MEMORANDUM

REHABILITATION PROJECT ASSESSMENT

St. James Park

DRAFT 04.01.19 REV 07.22.19 REV 12.11.19

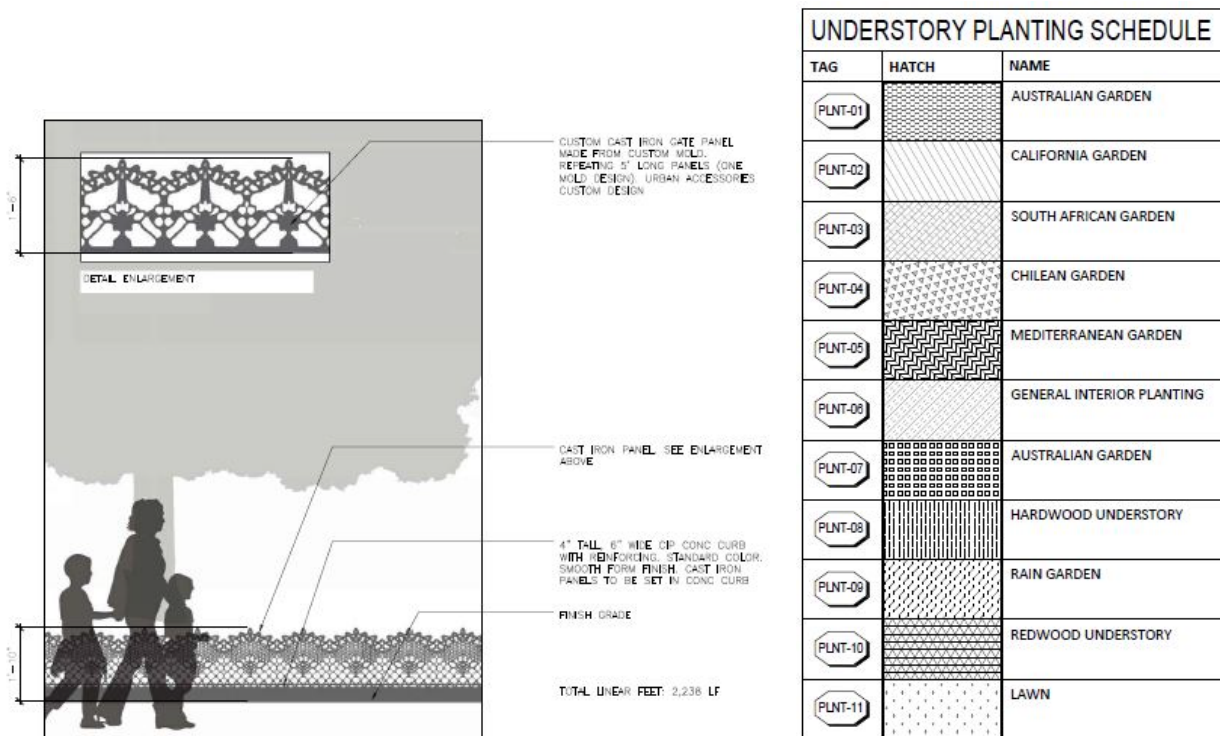
The perimeter border spaces will be relatively densely planted, low shrub areas punctuated with trees. They will be bounded by low decorative fencing. The borders are proposed to be planted in geographic groupings based on native source location. There is a meandering path within these plantings. Monument Walk and its paving materials is included in this portion of the review; it overlays parts of the current meandering path but does not follow the current path.

New defined park open spaces include the Naglee Picnic grove, the Plaza, a seating area northwest of McKinley Meadow, as well as McKinley Meadow and The Lawn.

Proposed structures or structural groupings (unroofed spaces with three-dimensional structures) include the Levitt Pavilion—made of folded, perforated-metal panels on curved tubular structural forms, a new playground, two dog parks to replace the recently installed dog park, the existing VTA station platform, and two trash enclosures. Within the park open spaces are smaller focal points. These include the existing three monuments (McKinley Statue, Robert F. Kennedy Memorial Podium, and a replaced location for the General Henry M. Naglee Monument) and one new fountain that replaces the remains of the non-historic replica fountain near the center of the site.
